DRAINAGE AREA MAP
 ADDISON COM CENTER
 JACKSON - SHAW COMPANY
 TOWN OF ADDISON, TEXAS

DESIGN	DRAWN	DATE	SCALE	NOTES	FILE	NO.
HALFF	CADD	SEPTEMBER 1999	1" = 40'	AVO 17986 986DAM		C-1

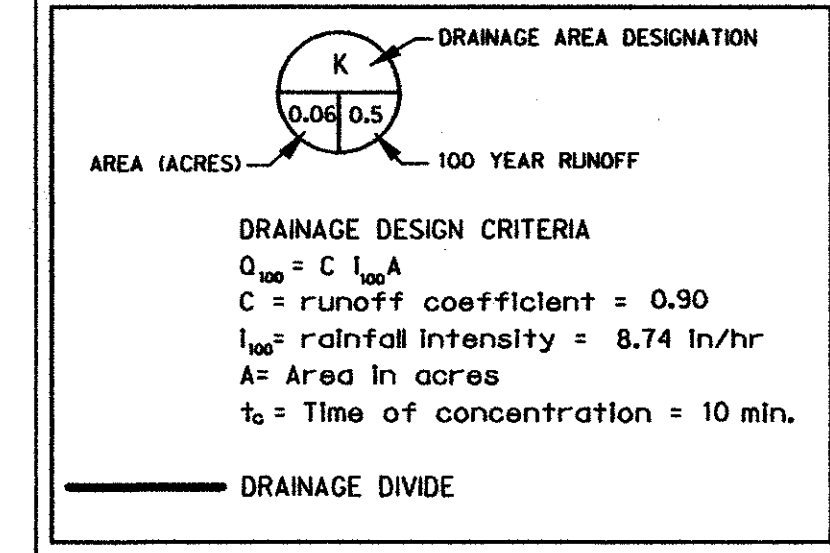
- △ "AS BUILT" BASED ON FIELD OBSERVATIONS OF SURFACE FEATURES ON MAY 4, 2000 AND CONTRACTOR PROVIDED INFORMATION. ELEVATIONS NOT FIELD VERIFIED. PARKING STRIPING NOT COMPLETED IN FIELD.
- △ 02-08-00, ADDED TRUCK WELL DRAINAGE AREA.
- △ 11-16-99, CHANGES TO DRAINAGE AREA DUE TO RELOCATED DUMPSTER.
